Economic Commission for Europe**Inland Transport Committee****World Forum for Harmonization of Vehicle Regulations****Working Party on Noise and Tyres**

Tyres: Supplement 01 to the new UN Regulation on studded tyres**Proposal for a Supplement 01 to the new UN Regulation on the uniform provisions concerning the approval of studded tyres with regard to their snow performance****Submitted by the Task Force on Studded Tyres***

The text reproduced below was prepared by the Task Force on Studded Tyres (TF ST) with the aim to include prescriptions of ice grip performance of tyres of class C1 to the new UN Regulation on uniform provisions concerning the approval of studded tyres with regard to their snow performance, following a mandate given by the Working Party on Noise and Tyres (GRBP) at its seventy-fourth session (ECE/TRANS/WP.29/GRBP/74). The modifications to the Working Document ECE/TRANS/WP.29/GRBP/2021/5r1e_0, as amended and adopted by the seventy-fourth (74th) GRBP, are marked in bold for new or strikethrough for deleted characters.

Figure 1 — stud protrusion device sketch

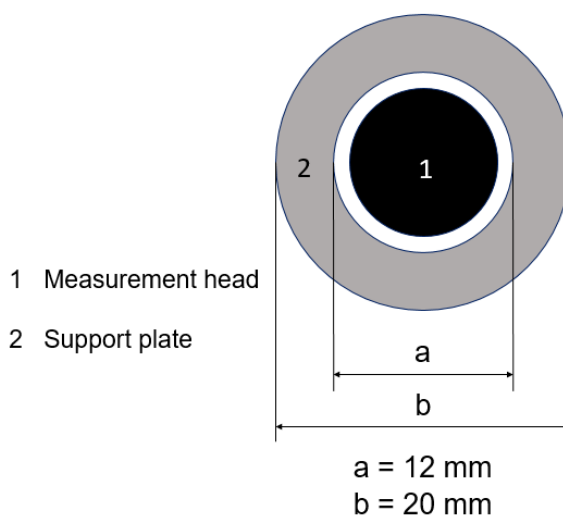
The stud protrusion measurement shall be done under the test inflation pressure conditions. Figure 1 illustrates the stud protrusion device. It shall be equipped with a support plate (2) of 20 mm diameter and a 12-mm diameter hole for the measurement head (1). The measurement head shall be pressed perpendicular to the tread surface with a force of 15 N to 20 N to trigger the measurement. The stud protrusion shall be measured from every test tyre, from 20 consecutive studs over the whole width of the tread and in circumferential direction, and at the same stud positions each time.
